**GOVERNMENT OF PUERTO RICO
PUBLIC SERVICE REGULATORY BOARD
PUERTO RICO ENERGY BUREAU**

IN RE: REVIEW OF THE PUERTO RICO
ELECTRIC POWER AUTHORITY
INTEGRATED RESOURCE PLAN

CASE NO.: CEPR-AP-2018-0001

FINAL RESOLUTION AND ORDER
ON THE PUERTO RICO ELECTRIC POWER AUTHORITY'S
INTEGRATED RESOURCE PLAN

Figure 1. PREPA Planning Reserve Margin With Existing Resources and Forecast Peak Load, 2019-2038

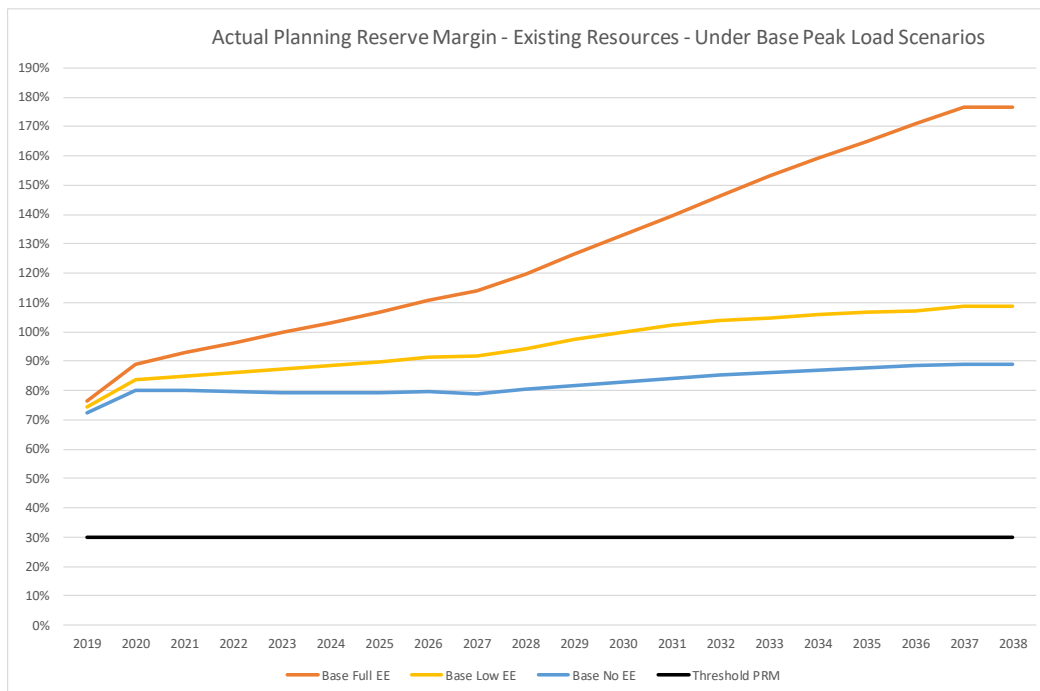
342. Figure 1 below incorporates PREPA's existing unit data (as seen in Table 3) and shows the PRM for the full existing fleet, under three different projections of peak load, for

Figure 2. Planning Reserve Margins Under Limited Availability of Certain Existing Resources

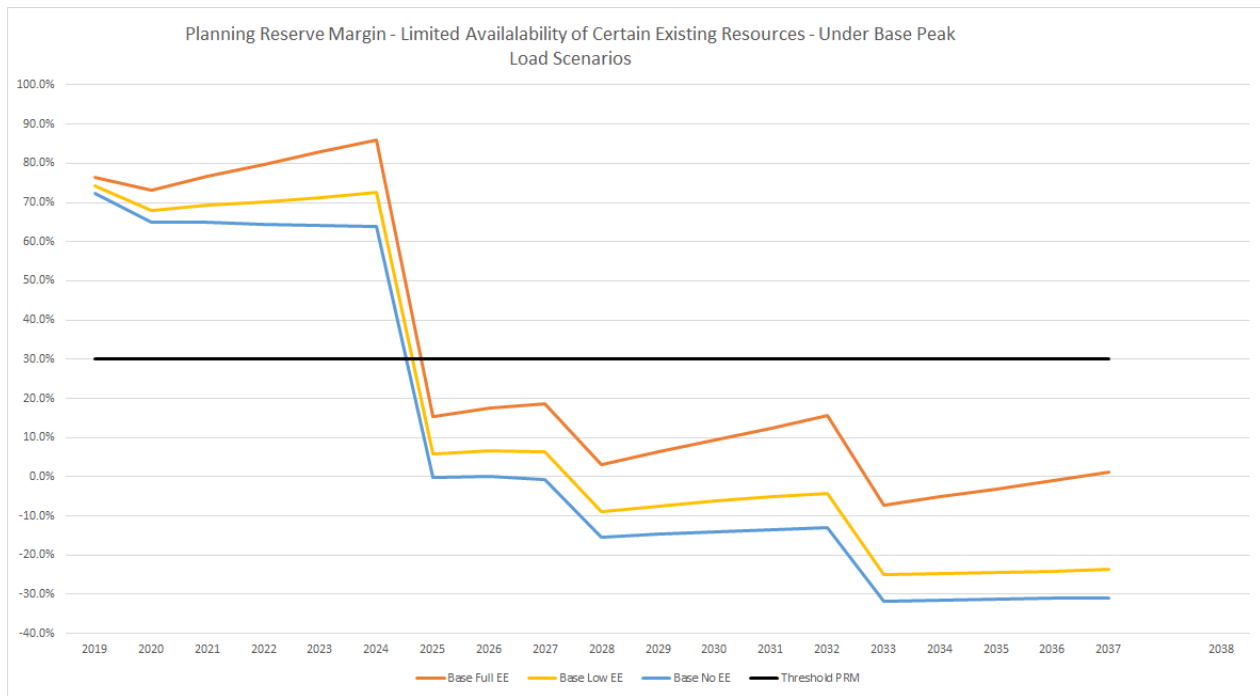
345. Figure 2 below illustrates PRMs on the system assuming that: (i) all MATS-impacted units retire by the end of 2024 (Aguirre 1&2, Palo Seco 3&4, San Juan 7&8); (ii) Aguirre CC units 1 & 2 retire by the end of 2024; (iii) that roughly half of the older GT units are not available as of 2020; and (iv) that Costa Sur 5&6 are returned to service, AES closes at the end of 2027, and the EcoEléctrica contract is not renewed after 2032.³⁵¹

Figure 3. PREPA Annual Net Position, MW, Existing Resource Base with Projected Closures, Retirements, and Reduced Availability

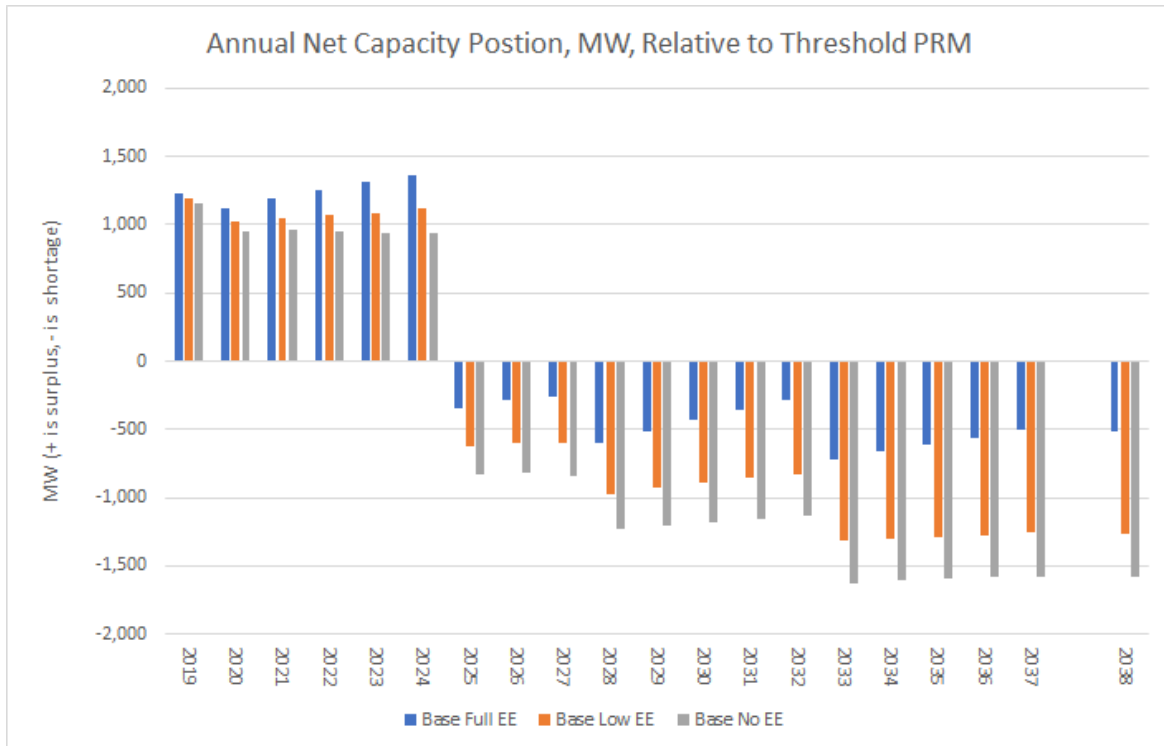
347. PREPA’s “annual net position”— i.e., the amount of capacity (surplus or shortage) relative to the threshold PRM—is readily derived from PREPA’s resources and load forecast data. Figure 3 below shows a range of the annual net position for the PRM circumstance illustrated above in Figure 2, for the three different “base” peak load forecasts.

348. Figure 3 above illustrates the range of capacity need PREPA faces given its load forecast outlook, and its existing resource base. The following observations can be made:

Figure 4. Annual Net Position with S4S2 Level of Battery Additions

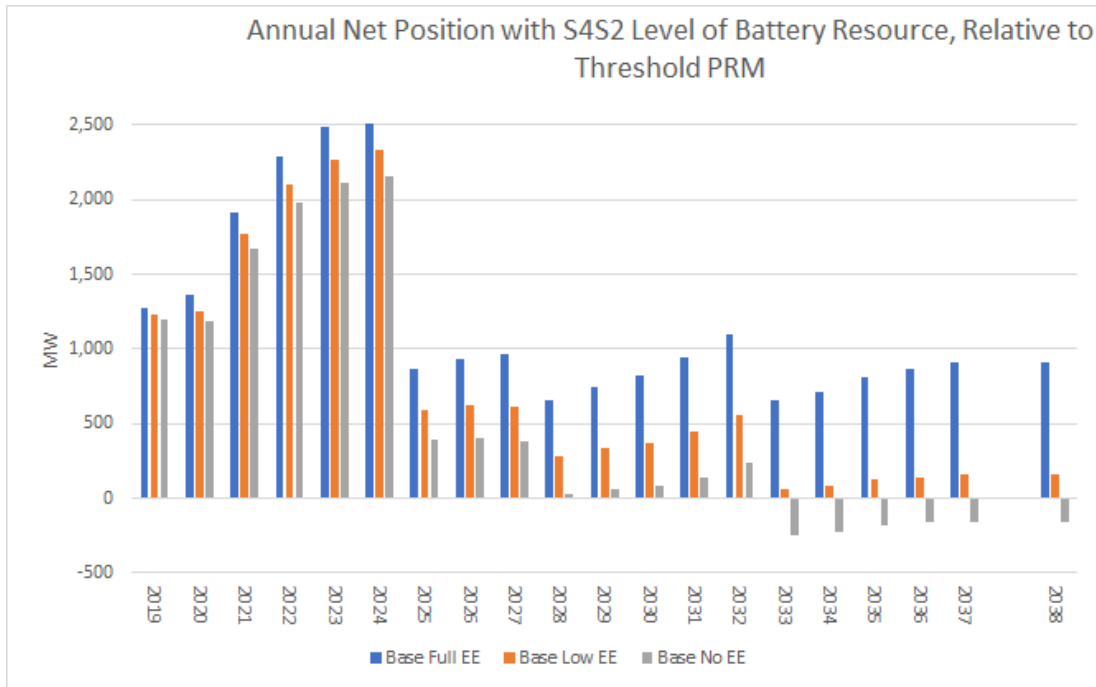
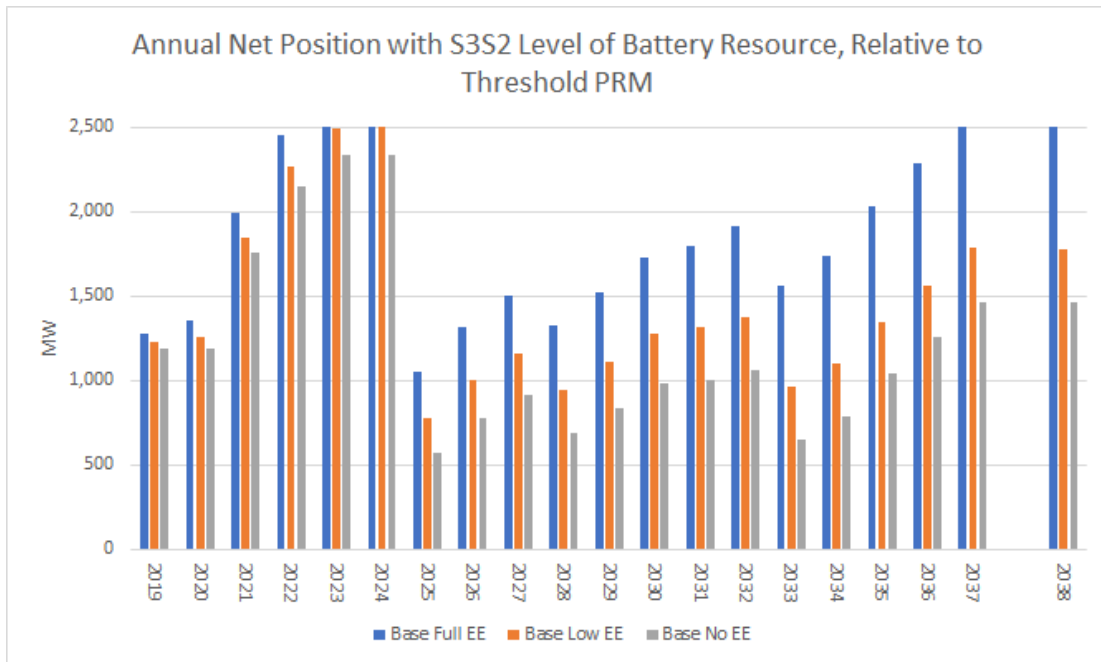
351. Figure 4 and Figure 5 above illustrate that batteries alone, without new fossil-fired capacity, could allow minimum PRM capacity needs to be met as MATS-impacted units retire, and assuming Costa Sur 5&6 remain in service (with any retirement or closure of return to service of either or both Costa Sur units, for the year or years in which they might retire, the “headroom” above minimum requirements is decreased). Higher levels of EE, as seen in the “Base Full EE” columns above, allow for the minimum reserve margin to be met with lower levels of battery installation because the peak load in Base Full EE scenarios is lower than in the other Base Low EE and Base No EE scenarios. Figure 5 also illustrates the importance of higher levels of peak load reduction from EE, and the presence of more battery capacity, in the later years when capacity from AES and EcoEléctrica may not be available. Figure 4 and Figure 5 show that with No EE or Low EE, 2025 and 2026 are critical years in the early portion of the planning period, when PRMs are at their lowest.

352. The PRM is high when counting all of the existing capacity but is much lower when both Costa Sur 5&6 and MATS-affected resources are unavailable, and when capacity is lost with AES and EcoEléctrica contract cessation, as seen in Figure 4 and Figure 5 above. This outcome indicates that increasing headroom (beyond minimum requirements) for economic retirement of MATS-impacted units will occur only after capacity installations.³⁵⁵ Capacity installations are represented by the battery resources chosen in S4S2 and S3S2 and seen in Figure 4 and Figure 5.

353. This analysis further indicates that new gas-fired peaker replacements are not necessarily required for PRM purposes. This outcome assumes that: if it is assumed that battery resources of a similar scale as required in PREPA’s scenarios will be installed – first - in accordance with the early-year timelines in those scenarios; and that the capacity at Costa Sur 5&6 remains at least until such battery resource installations allow PREPA’s annual net position to be higher than the Costa Sur units’ output, which is seen in Figure 5 as occurring as early as 2025, provided that peak reductions from “full” EE resources are captured. The exception to this finding, that gas-fired resources are not needed, exists only if one abides by PREPA’s definition of capacity need under the proposed MiniGrid construct. That construct imposes effectively higher PRMs on the system and directly states that “thermal” or fossil-fired resources are required.³⁵⁶

Figure 7. WTI Forecast: PREPA, AEO 2018, AEO 2020, and STEO June 2020 (\$/barrel nominal)

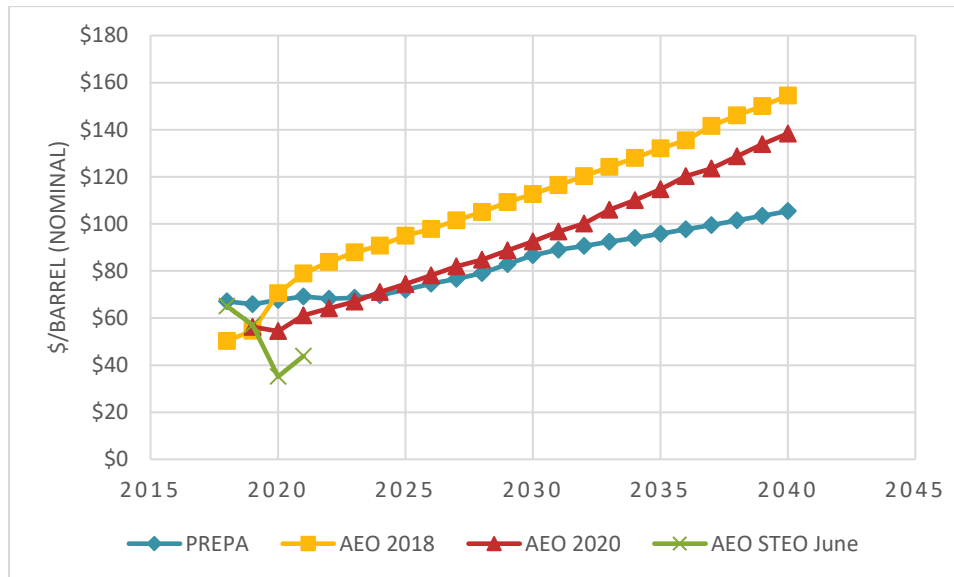
544. PREPA's forecast of commodity crude oil prices (WTI) is based on a comparison and average of a variety of forecasts including EIA and IEA.⁷⁰⁷ As noted above, PREPA provided a comparison of its WTI crude oil forecast with AEO 2018. AEO 2020 contains an updated crude oil forecast but, as stated above, does not account for the current
